Response to Reviewer 1 (Prof. Dr. Werner Eugster)

Thank you for your detailed remarks and constructive comments which are all very helpful for improving the manuscript. We are glad that you find our work interesting and innovative. We are particularly grateful for the substantial work to understand all details, which will help us clarify the text and improve the presentation. As noted, our aim is to provide a detailed fully open-source description of the system that can contribute to more extensive data collection and to inspire technical improvements by the broader community. Our response to your specific review comments are given below.

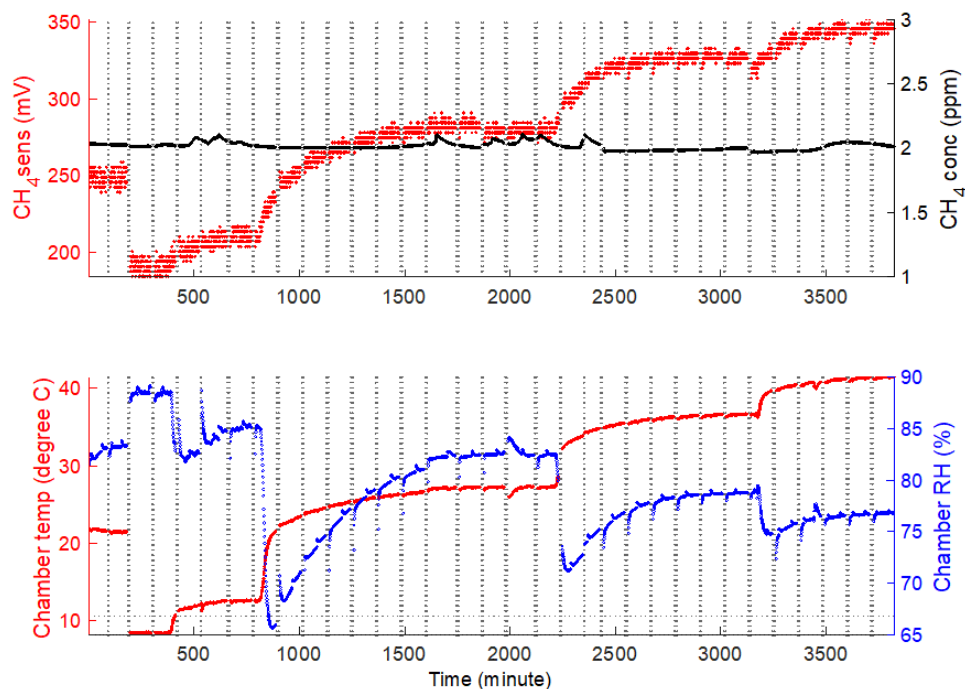
*2.1 RC2:* I am concerned about the low voltages that the TGS2611-E00 gives, ca. 18–35 mV according to Fig. 3. The TGS2600 that I use delivers 200–400 mV for ambient conditions, and when I look at the specifications it appears that the manufacturer considers the TGS2611-E00 to be useful in the range of 300–10,000 ppm CH<sub>4</sub> which is way above ambient range (the TGS2600 is shown with a sensitivity to CH<sub>4</sub> in the range 1–100 ppm CH<sub>4</sub> that's the reason we selected this one for near ambient measurements in Eugster & Kling, 2012). Now there are some other publications that show that the TGS2611-E00 is actually sensitive also to near ambient conditions, but I am not yet convinced that this is the best choice for your application given the low CH<sub>4</sub> concentrations well below the range

indicated on the technical specification sheet of the manufacturer. Some more critical discussion on the sensor selection would be required in my view.

2.1 AR2: This question highlights and revealed an error in the script for plotting the scale of Fig. 3A. The corrected Figure 3 is pasted below. The background level of the NGM2611-E13 sensor should be in the range of few hundred millivolts, in line with your expectations.

2.1 ACM2: The error in the scale of Figure 3 have been corrected and clarifications on sensor details and motives behind the sensor selection will be made (see ACM1 above).

### **Basic Measuring Circuit:**

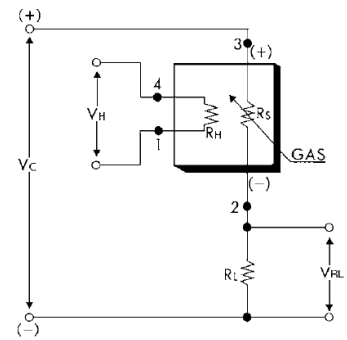
2.1 RC7: According to the manufacturers information the sensor resistance decreases as the CH<sub>4</sub> concentration increases, thus in principle the voltage you measure should decrease not increase with increasing CH<sub>4</sub> – but your measurements in Fig. 4 show the exact opposite of what one would expect from the manufacturer information. Do you have an explanation for this? I must admit that on short timescales I see the same (see Figure inserted below), but on longer timescales I see what I would expect from the manufacturer's data sheet. Our procedure suggested by Eugster & Kling (2012) solve this issue with the calibration – after linearisation the use of a high and low calibration point simply reverses the sign if the response is of the kind that you show in Fig. 4. If you have an explanation why the TGS2611-E00 has increasing voltage with increasing CH<sub>4</sub> concentration then this would be a helpful insight for the reader. If you don't have an explanation, maybe you have an opinion?

2.1 AR7: From our understanding, the NGM2611-E00 and the TGS 2611 sensor in a circuit essentially operates as a voltage divider. A figure and associated text from the Product Information note of TGS 2611 ([https://www.figaro.co.jp/en/product/docs/tgs2611\\_product\\_information\\_rev02.pdf](https://www.figaro.co.jp/en/product/docs/tgs2611_product_information_rev02.pdf)) is provided below. The resistance of the CH<sub>4</sub> sensor is called R<sub>s</sub> which has a resistance value that decreases as CH<sub>4</sub> concentration increases, load resistor R<sub>L</sub> has constant value (about 5 kΩ). This circuit is fed by a constant circuit voltage V<sub>C</sub> (5V), and the current equals to ratio of 5/(R<sub>s</sub>+R<sub>L</sub>). Hence, if R<sub>s</sub> decreases, the current will increase. As a result, output voltage (V<sub>RL</sub>) which equals to R<sub>L</sub>\*5/(R<sub>s</sub>+R<sub>L</sub>) will increase. We have not studied the circuit details for other sensors so perhaps interpretations of the output voltage differ among sensors which may be the reason for this comment. We will double check our understanding and if it seems OK we will try to clarify this in the supplementary material.

The sensor requires two voltage inputs: heater voltage ( $V_H$ ) and circuit voltage ( $V_C$ ). The heater voltage ( $V_H$ ) is applied to the integrated heater in order to maintain the sensing element at a specific temperature which is optimal for sensing. Circuit voltage ( $V_C$ ) is applied to allow measurement of voltage ( $V_{RL}$ ) across a load resistor ( $R_L$ ) which is connected in series with the sensor.

A common power supply circuit can be used for both  $V_C$  and  $V_H$  to fulfill the sensor's electrical requirements. The value of the load resistor ( $R_L$ ) should be chosen to optimize the alarm threshold value, keeping power dissipation ( $P_S$ ) of the semiconductor below a limit of 15mW. Power dissipation ( $P_S$ ) will be highest when the value of  $R_S$  is equal to  $R_L$  on exposure to gas.

2.1 ACM7: The above explanation will be clarified in the supplementary material.
